14 November 2024

RE: HIA Feedback on Draft Queensland Housing Code

Figure 2: Setback information for different lot types

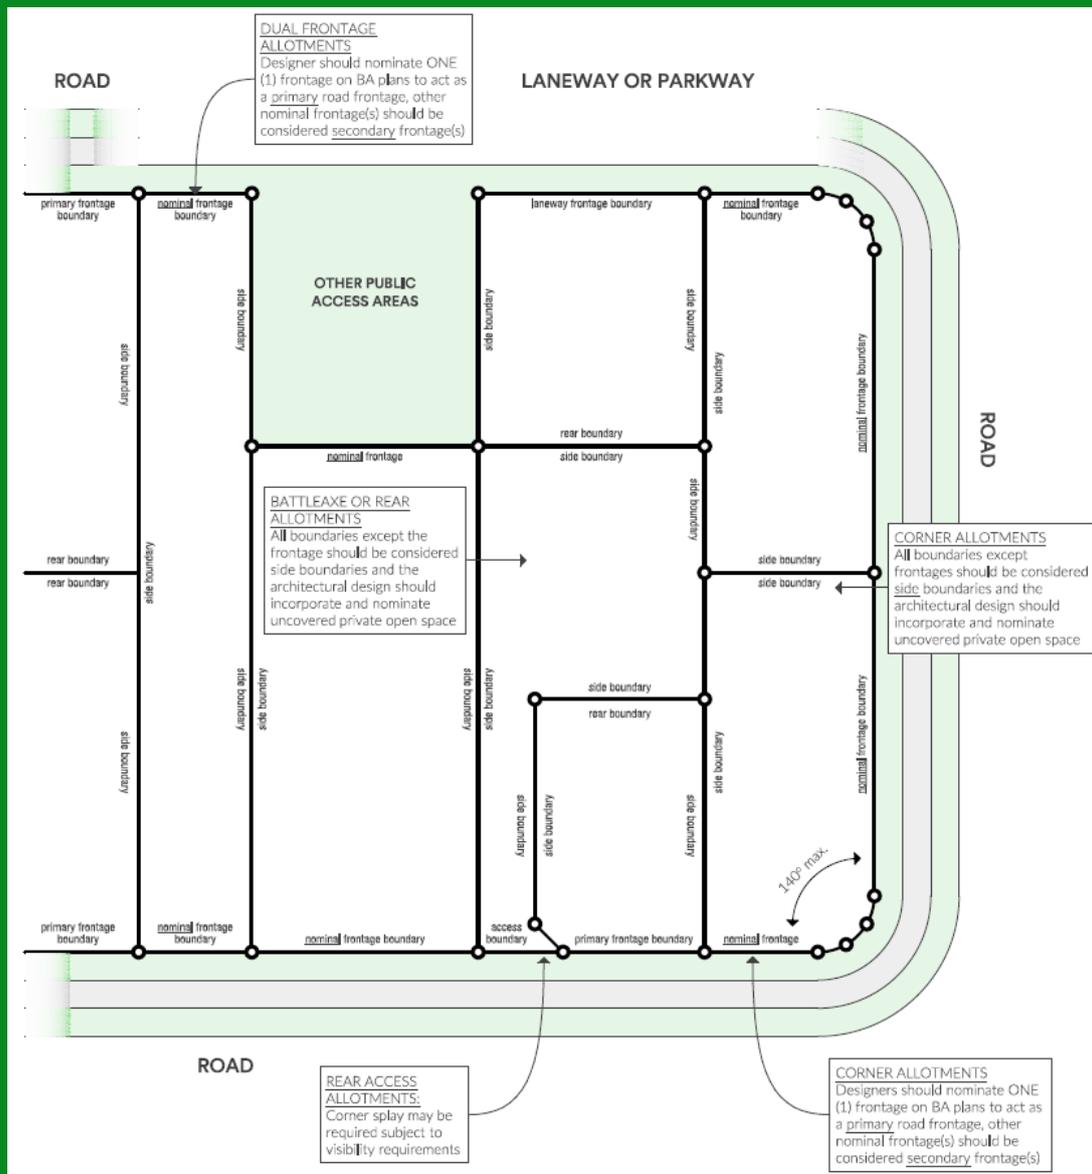
This definition should be provided with the following diagram detailing boundaries for different lot configurations.

Provide guidance to industry on the calculation of lot width and determination of a rear boundary for corner allotments. HIA notes the preferred approach is for corner allotments to not have a rear boundary and to have two side boundaries and two road frontage boundaries which has been adopted by most local governments. Refer to Figure 2 for the preferred arrangement.

Figure 3: Example of allotments exceeding 450m² by 10m width

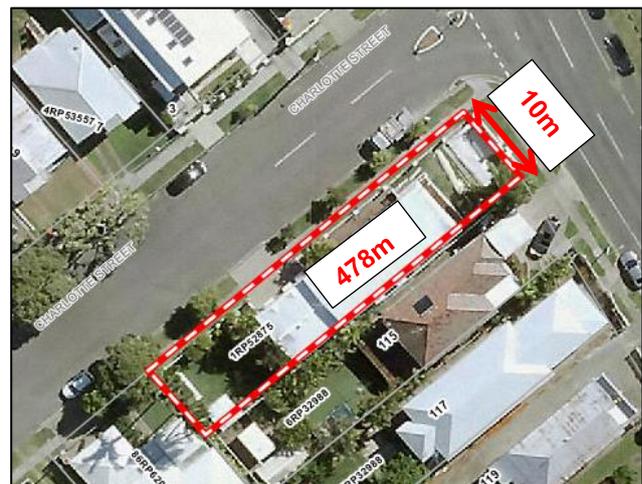
Some example imagery of properties exceeding 450m² which have an average width of 10m to 11m is below. HIA has tested the proposed boundary setbacks to illustrate how restrictive the QHC is for narrow allotments which exceed 450m² (see Figures 3 & 4 below).

HIA suggests a 1.5m secondary frontage boundary setback is suitable. This is consistent with the requirements specified under the QHC Chapter 2 – Lots under 450sqm.

Figure 4: Review of setbacks for corner allotments

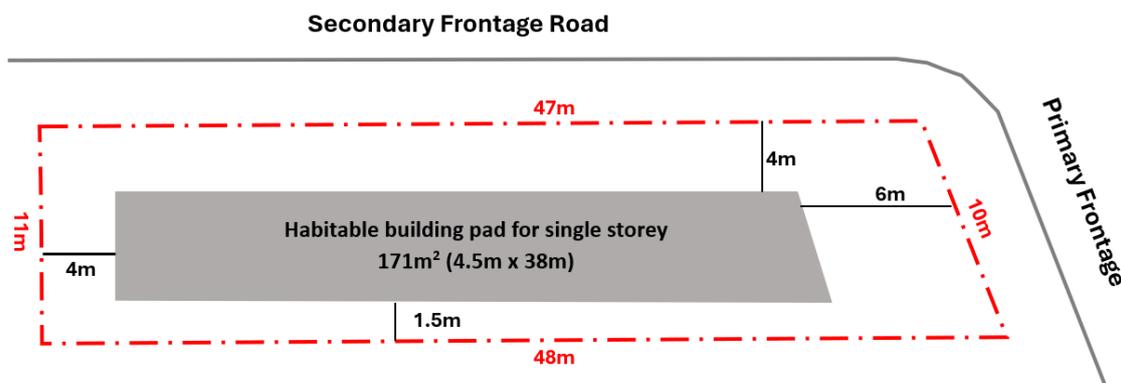
The secondary road frontage setback for 450m² or greater allotments, in combination with a 1.5m to 2m side boundary setback would result in space only 4.5m wide for habitable spaces. Concerningly, some non-habitable spaces require even a greater secondary frontage boundary setback than 4m. This outcome will not be accepted by industry and will result in a high volume of siting applications.

Alternatively, consideration should be given to a sliding scale to setbacks based on average width of the allotment. This outcome would be consistent with HIA’s Housing Code.

Figure 7: Perverse outcome of 3.5m height restriction for 'covered outdoor room'

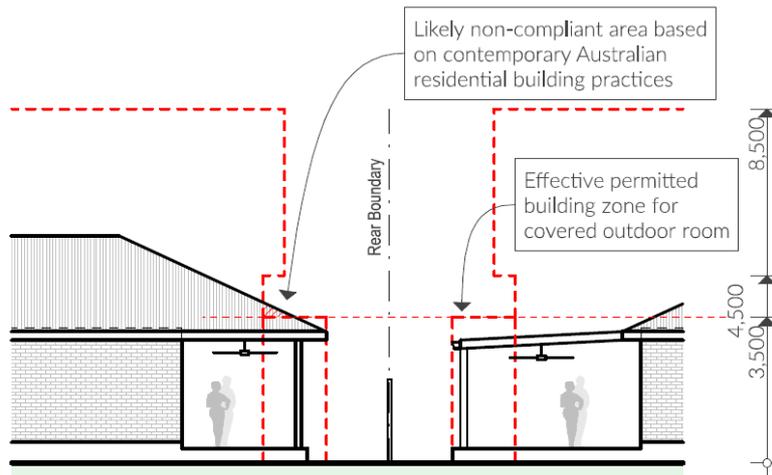
While HIA is supportive of the reduced boundary setback permitted for a 'covered outdoor room' which is vital to ensure a roofed patio area can be achieved, the maximum height restriction of 3.5m needs to be reconsidered.

The height restriction of 3.5m prevents integrating the patio space with the remainder of the roof form which is a far more cost effective solution. A design response to comply with the maximum 3.5m height restriction is a flat lean-to style of patio roof rather than a roof form that is pitched and integrates with the remainder of the dwelling house. This provision is preventing a superior outcome from an energy efficiency and occupant comfort perspective as no roof cavity space can be provided which would be properly insulated and serviced.

HIA's suggests the height restriction for 'covered outdoor room' should permit a pitched roof form and integration with the remainder of the dwelling house as follows:

- A maximum building height of 3.5m above ground level at side and rear boundary setbacks, increasing at no more than 30 degrees to a maximum building height of 4.5m above ground level.

Figure 9: Example of existing house built on front boundary

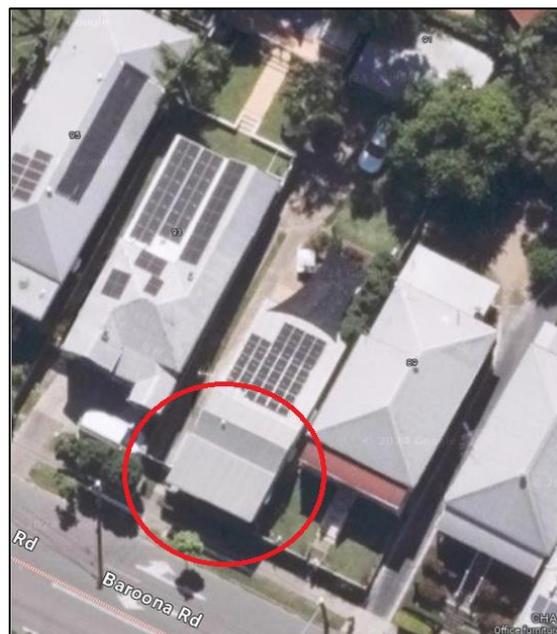
HIA reminds the Department that the QHC applies to renovations and additions. As such, the requirement to provide landscaping adjacent to the frontage will not be achievable when involving an existing house built on the front boundary alignment (see Figure 9 below for example).

An extension to the rear of the above house would trigger a concurrence agency referral as it is not possible to provide landscaping adjacent to the frontage. HIA does not support landscaping provisions in the QHC. Homeowners should be able to select the appropriate location for landscaping based on their preferred house design and living circumstances.

Provisions for the location of landscaping should be removed to provide flexibility to homeowners and to consider renovations and additions to existing houses.

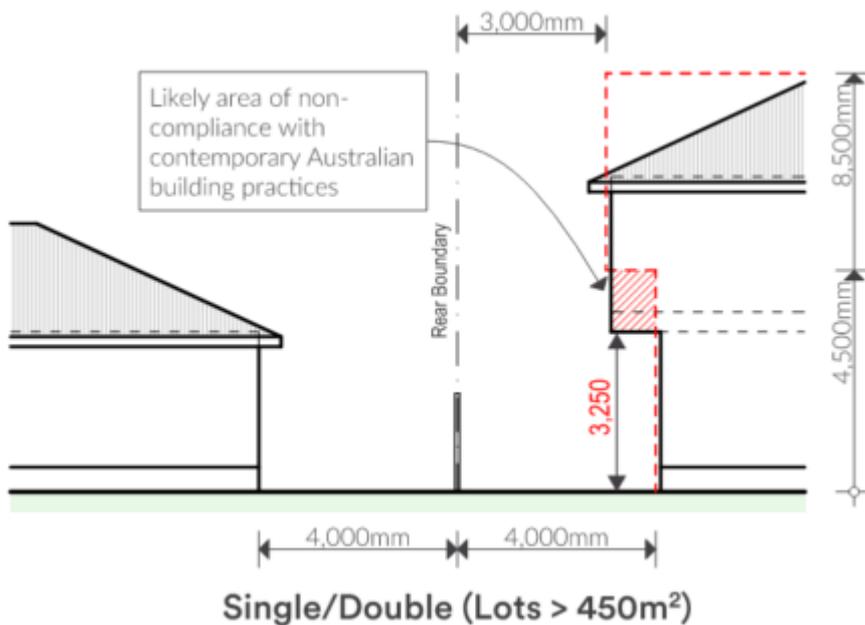
Table 3. The setbacks highlighted above are too large for allotments that are narrow. QDC MP 1.2, Table A2 facilitates this, albeit very outdated now. Master planned communities have side setback table that also facilitate this very well and this must be accommodated in the QHC Chapter 1. Allotments 450m² or greater often have an overall width less than 12.5m, and this is where a reduced side setback relevant to the allotment width is necessary.

Table 3 notes. The notes describe the situation that allows the upper storey to cantilever at least 1.0m over the lower storey or an outdoor living area. The description will not deliver what is intended due to the heights listed for each setback. To illustrate where this fails, Provided below is a diagram that shows the area of cantilevered upper storey wall (indicated with a red cross hatch) that does not meet the setbacks described. The descriptive in Table 3 needs to change to alleviate the unintentional consequences for the industry professionals.

The lower storey outdoor living area will generally be greater than the 1.0m cantilever in depth and this will require support posts for the upper storey as a cantilever greater than 1.0m deep, or the depth of the outdoor living area is very costly. The notes included below Table 3 need to facilitate the inclusion of support posts located at the upper storey setback. This would still provide an open area below the upper storey while also being mindful of typical construction methods and housing affordability.

Rear Alfresco Setbacks

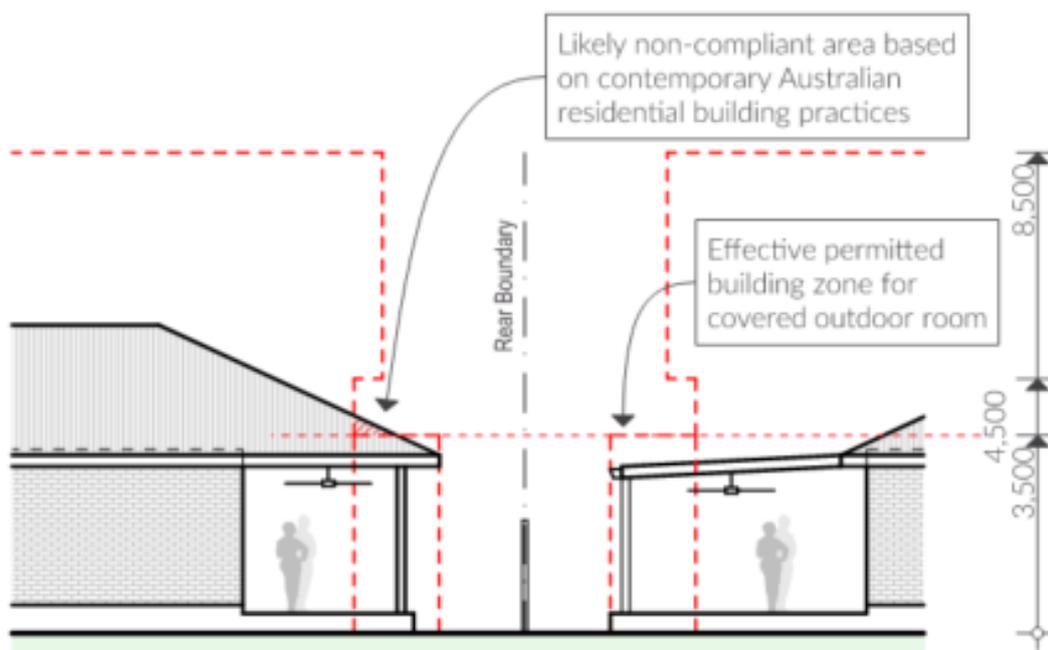
The diagram below shows why this is difficult to achieve an outdoor room less than 3.5m in height using typical building materials & methods. The result is accepting an insulated roof sheeting patio extension that isn't what the consumer wants today. Additional to having a 1980's patio roof, the installation of a ceiling fan and achieving the thermal download requirements potentially, means that the QLD energy efficiency credits for the outdoor living space may not be achievable.

Figure 5 — Private open space (POS) example options

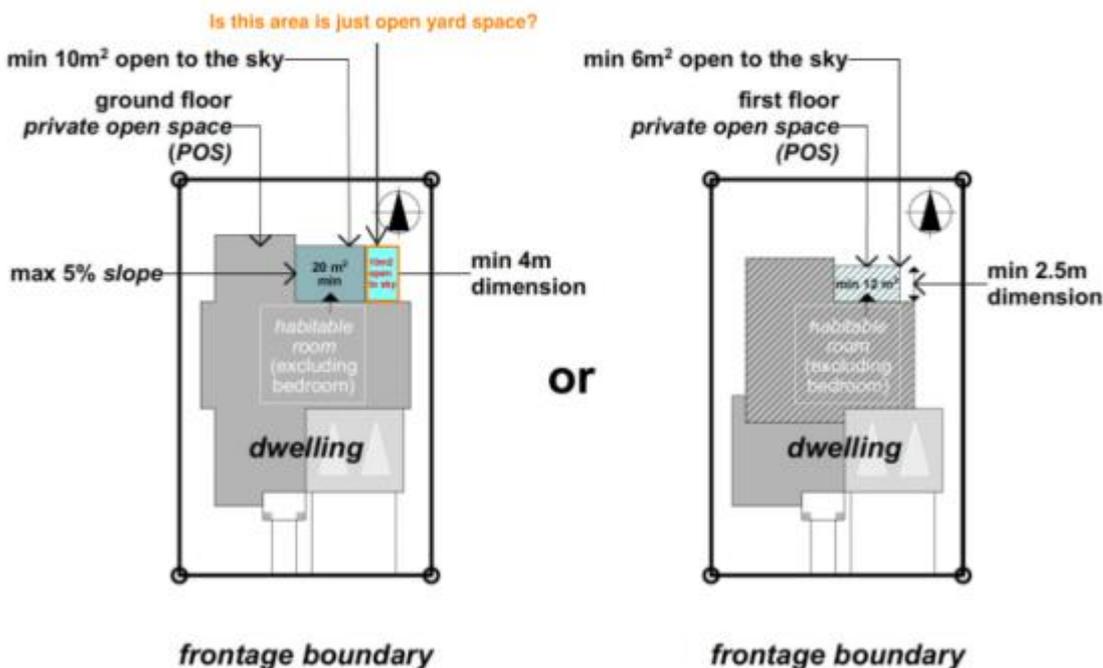
Table 8 - A minimum area of private open space is to be provided, and this can be the area of the outdoor room, yet the diagrams below do not clearly identify if the 50% portion of this area can just the open yard space. For the upper storey balcony, having a portion of this open to the sky is going to increase the maintenance requirements of the balcony dramatically. This item needs further attention and consultation with the building industry.

Diagram A

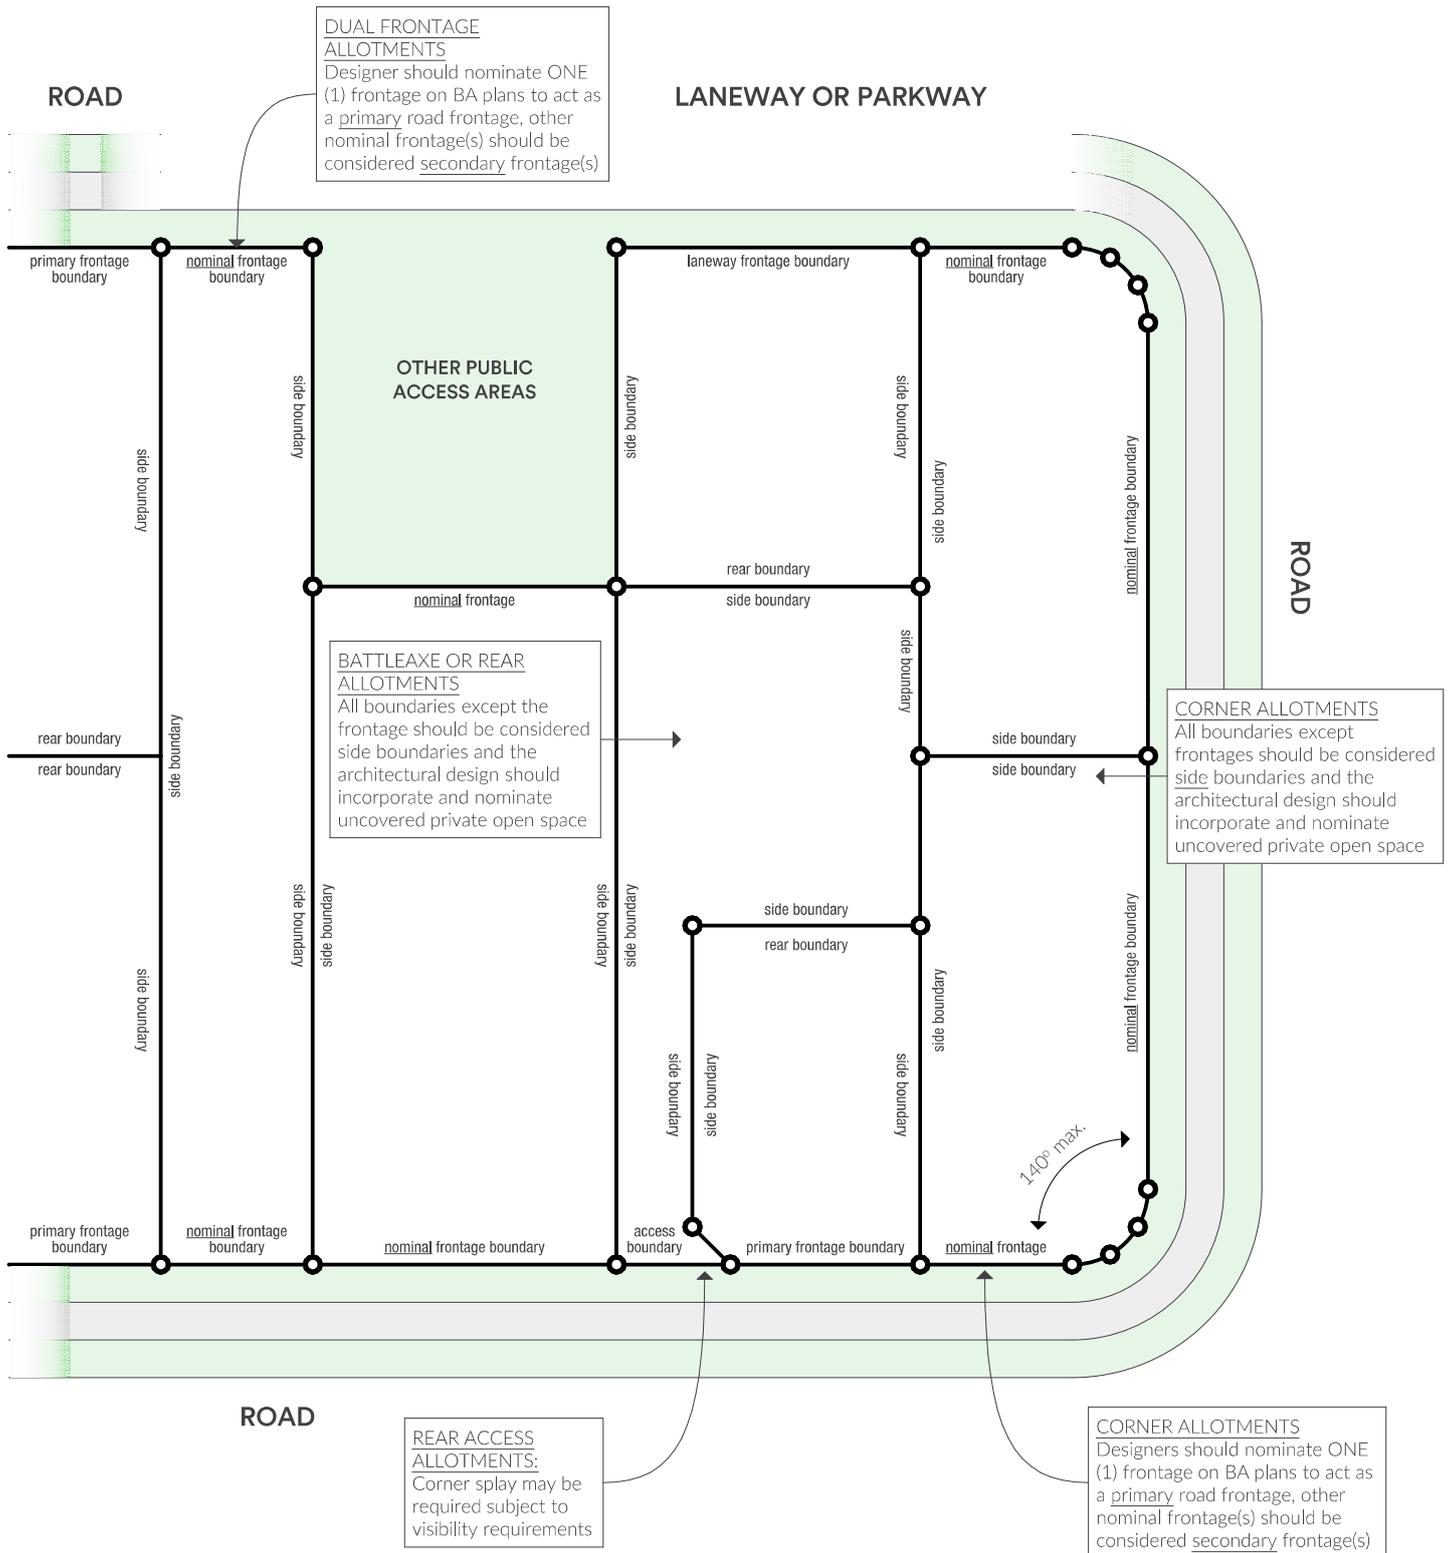
The allotment configuration, shape, size & orientation will be the determining factor of which boundary would be classified as a rear boundary.

Boundary Location Diagram & Comments

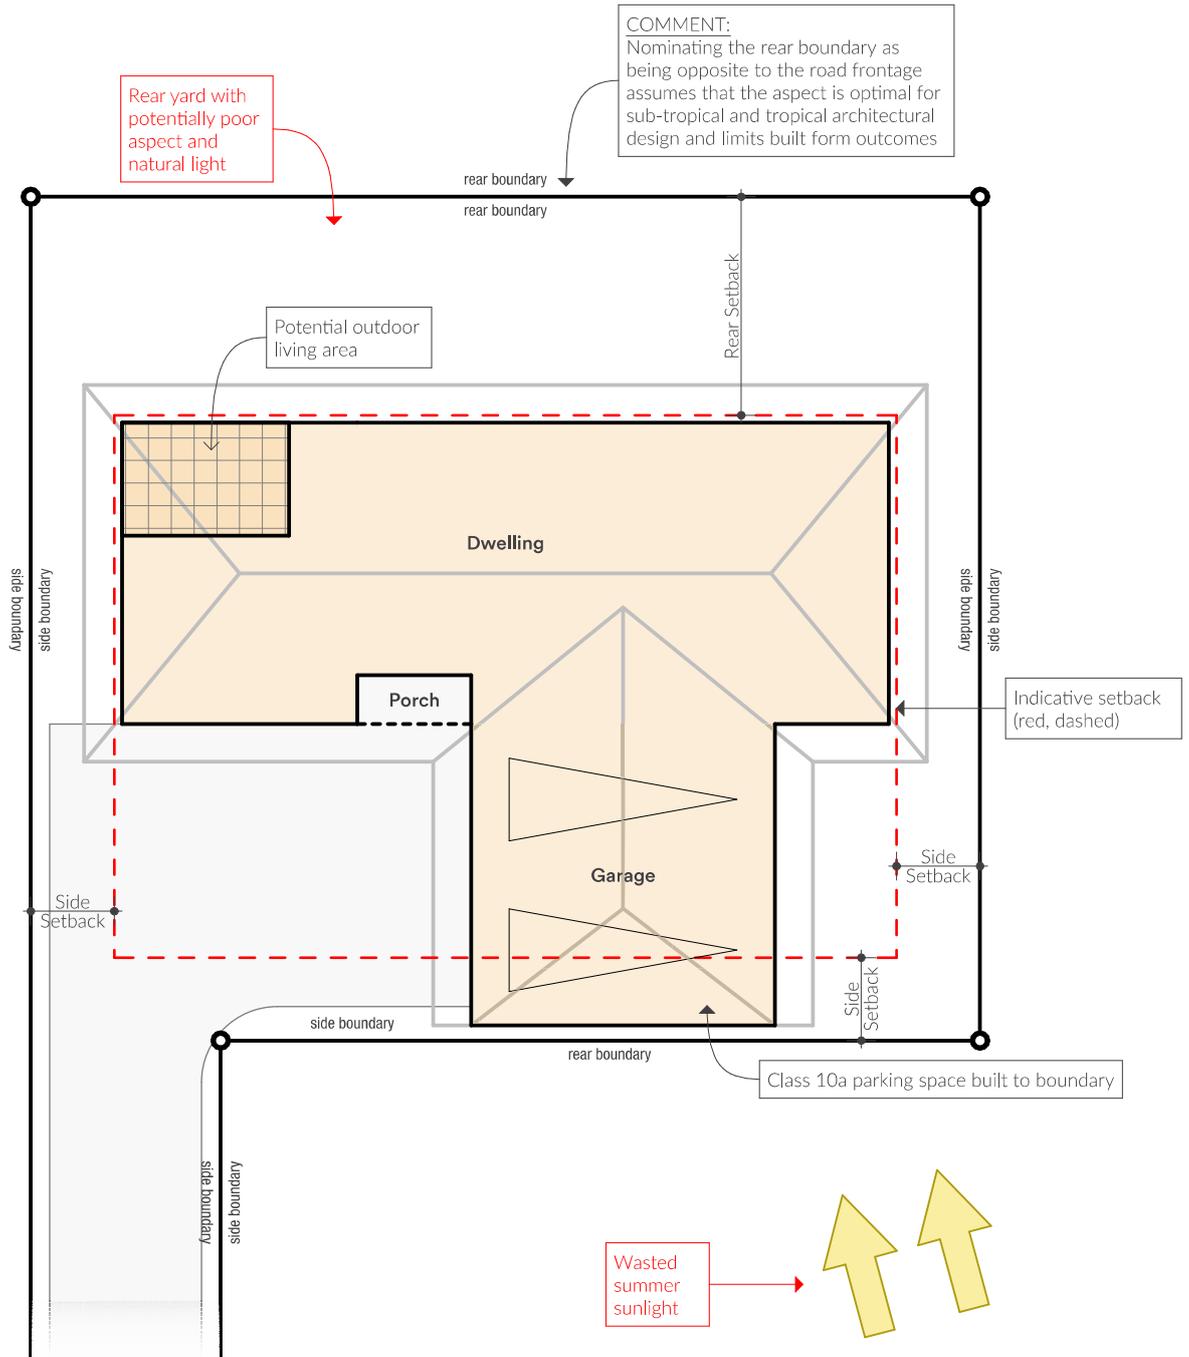
The allotment configuration, shape, size & orientation will be the determining factor of which boundary would be classified as a rear boundary.
